# Access Compliance Report

## Public Rights-of-Way

### (Curb Ramps)

Intersection ID: 12215	Main Street: MIDLAND_AV	Cross Street: DAVIS_AV	Location: NW
ADA ID: 79BA7EE20C98	Ramp Type: BlendTrans1	Initial Pass/Fail: Fail	Overall Compliance: No
		Severity Score: 8.75

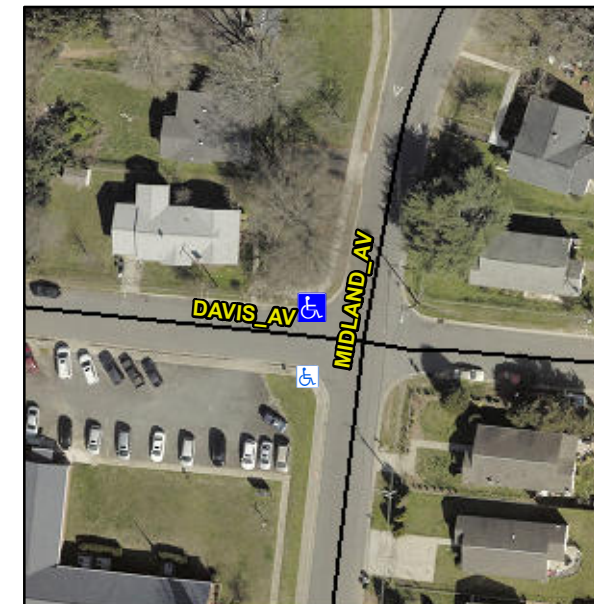
**Not Found, R304.5.1**

**Remove & Replace Curb Ramp With Two New Directional Ramps or Equivalent.**
